Submittal #260500-1.0 260500 - Common Work Results for Electrical

Project: 128.060.001 - Dutchess Stadium New Clubhouse &
 Improvements
 1500 NY-9D
 Wappingers Falls, New York 12590

Common Work Results for Electrical - Sleeves Product Information

Project Name: Dutchess Stadium Left Field Clubhouse
 Project Number: 57-21113-01
 Submittal ID: 260500-1.0
 Received On: 4/10/2023
 Reviewed On: 4/14/2023
 Reviewed By: Collin Wheeler

Concrete Pipe Sleeves

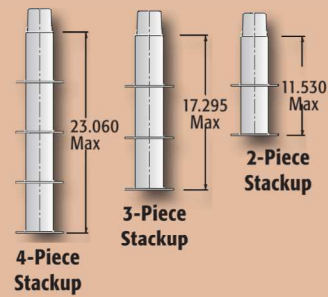
*** Provide fire-rated sleeves as specified for penetrations through fire-rated walls/floors.**

*** Provide EMT sleeves for penetrations through non-rated walls/floors.**

*** Refer to specs for acceptable sleeve type application.**
